SONGS Units 2 and 3 Soluble Boron Credit

Propose Change Number (PCN) 556

Purpose of SCE Presentation

FIGURE 3.7.18-1

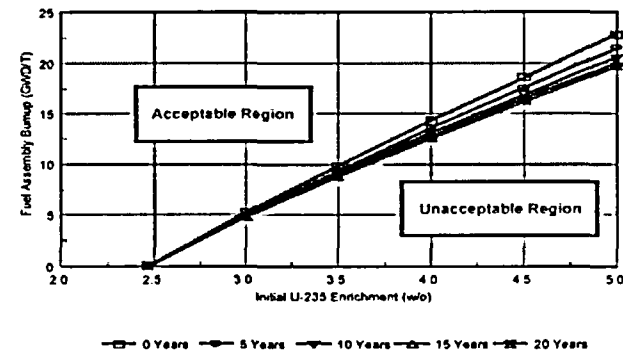
Two curves similar to the curve on the left are to be replaced by 4 curves similar to the curve on the right.

FIGURE 3.7.18-1

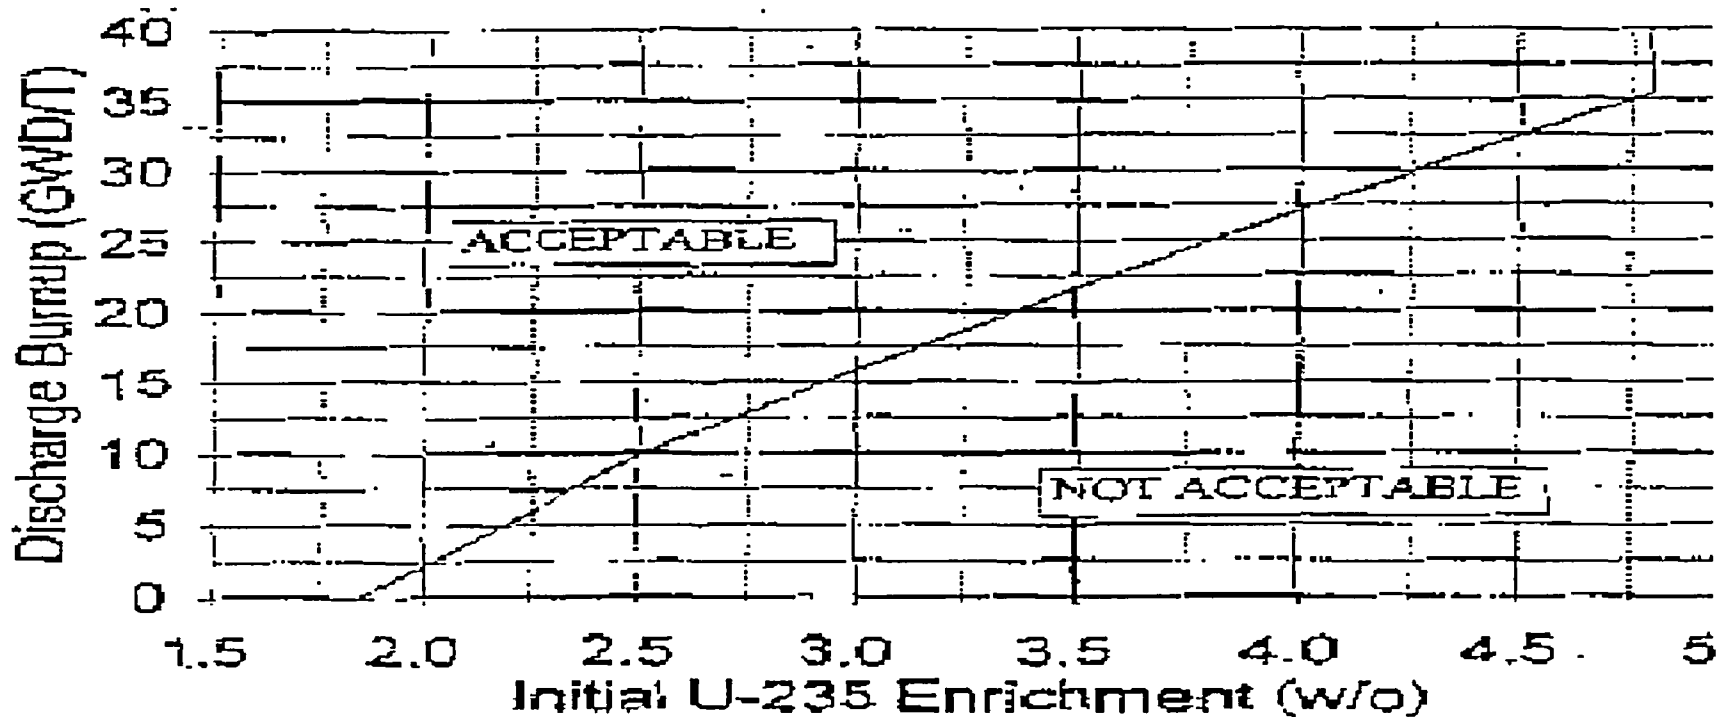
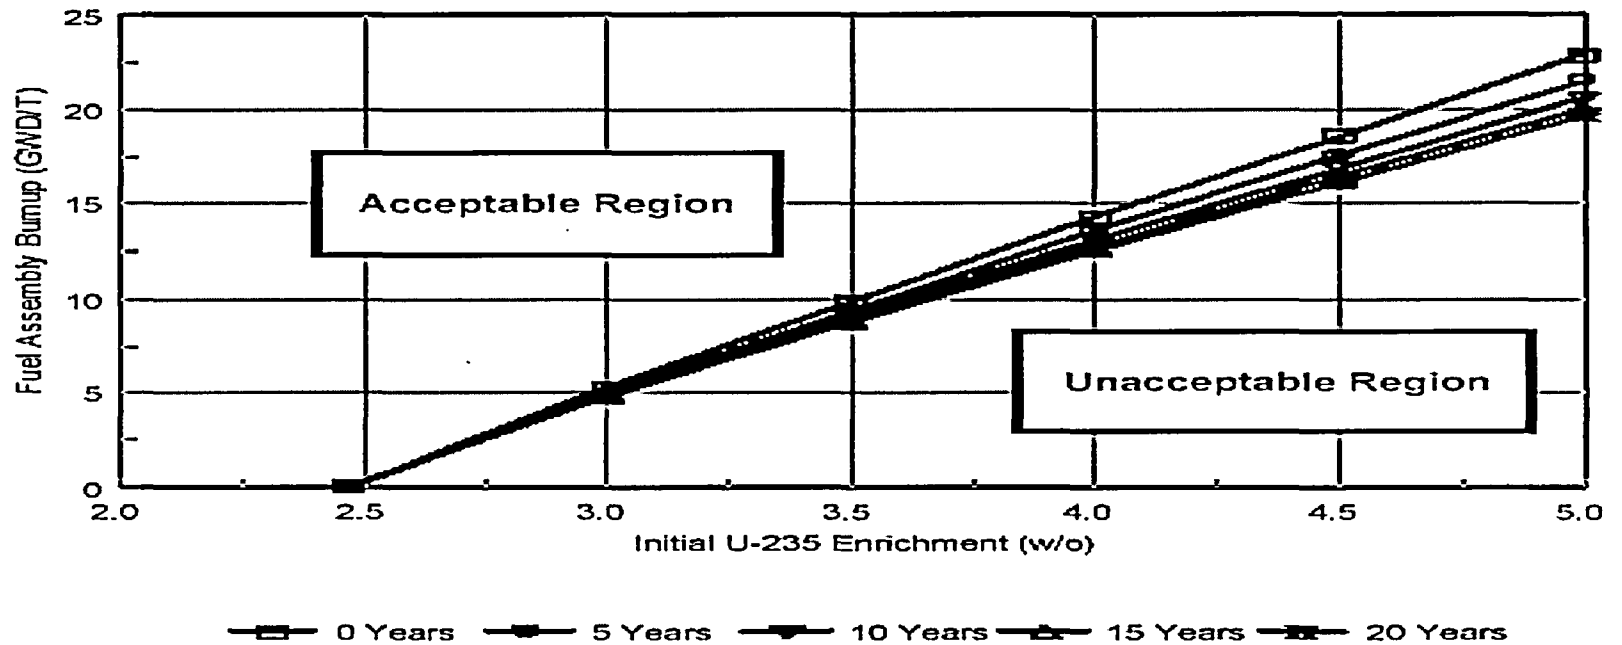
Proposed Change to 3.7.18

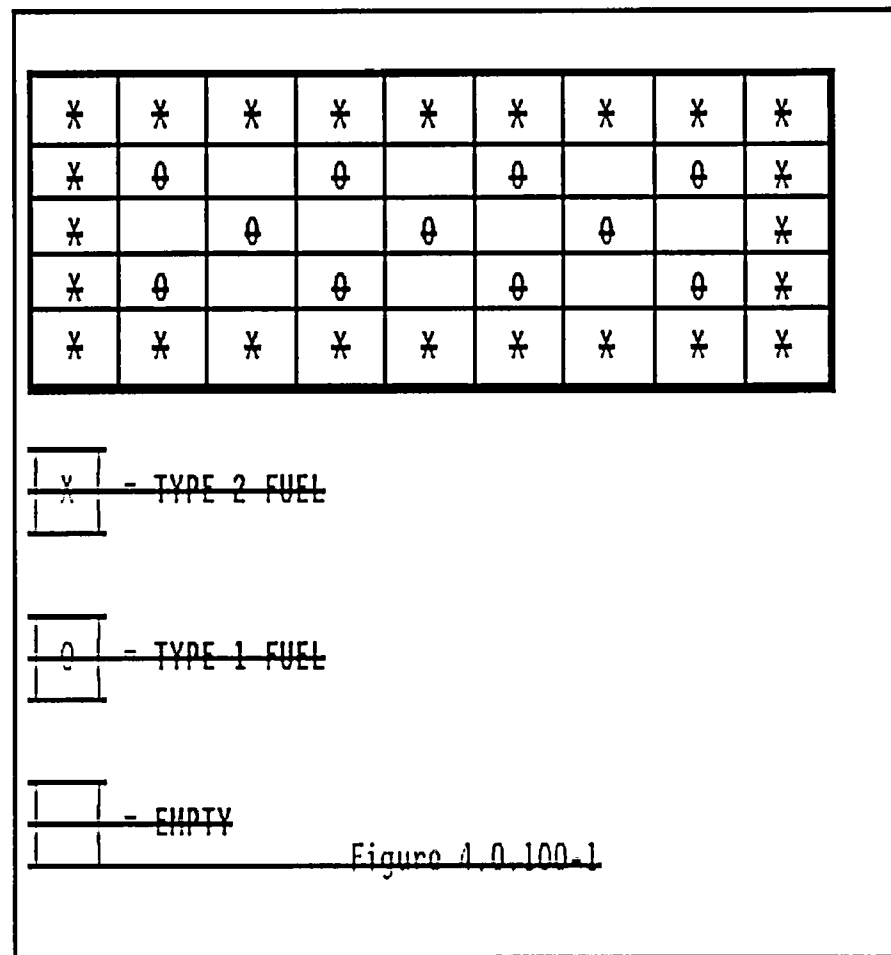
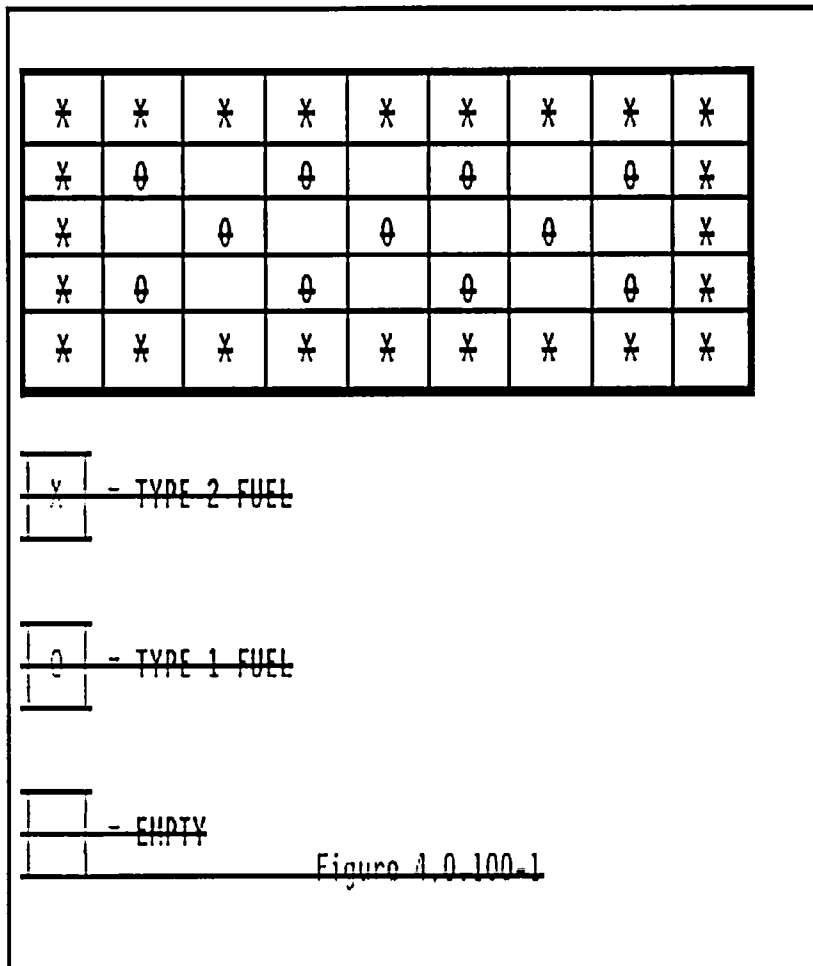
The two figures below are to be replaced by
54 tables and figures
